RE: Response to Aurora's Initial Submission Review Comments for Colorado's Power Pathway Conditional Use and Site Plan (DA-2384-00)

RESPONSE TO INITIAL SUBMISSION REVIEW COMMENTS

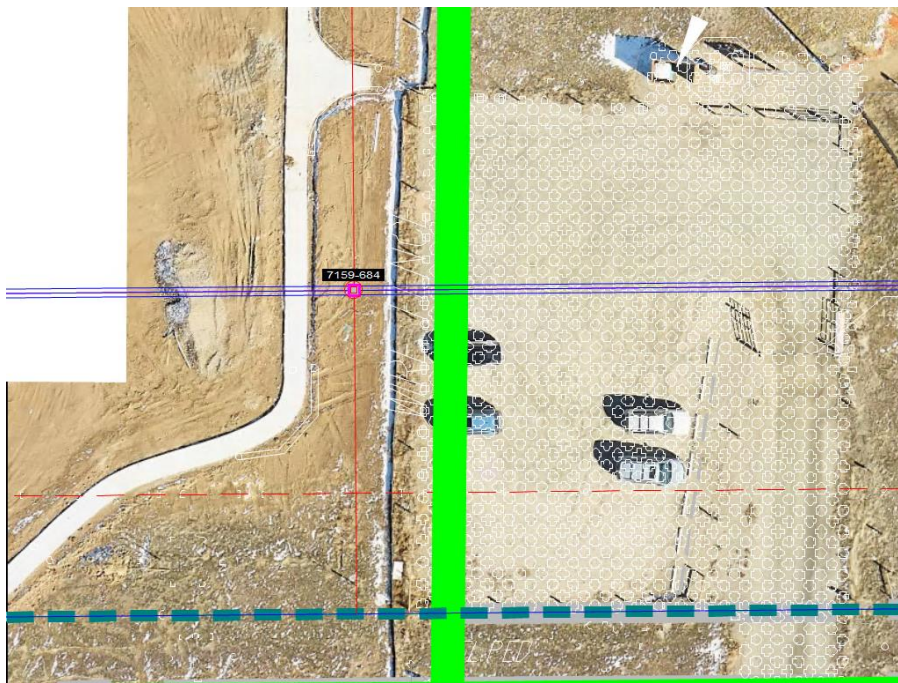
Comment 5A: Can this pole be moved to the west roughly 20 feet? There are no plans to extend Robertsdale Way north at this time. This would be a logical place for a 2-lane collector in the future if it is needed.

Response: Xcel Energy has reviewed this comment and has determined that this pole (#684) would be located west of the existing parking lot and east of the City of Aurora road has already built (see screenshot below). Moving this pole 20 feet to the west would put it in the existing road. (Note that, based on this information, PROS has withdrawn its comment requesting the pole be moved to the west.)
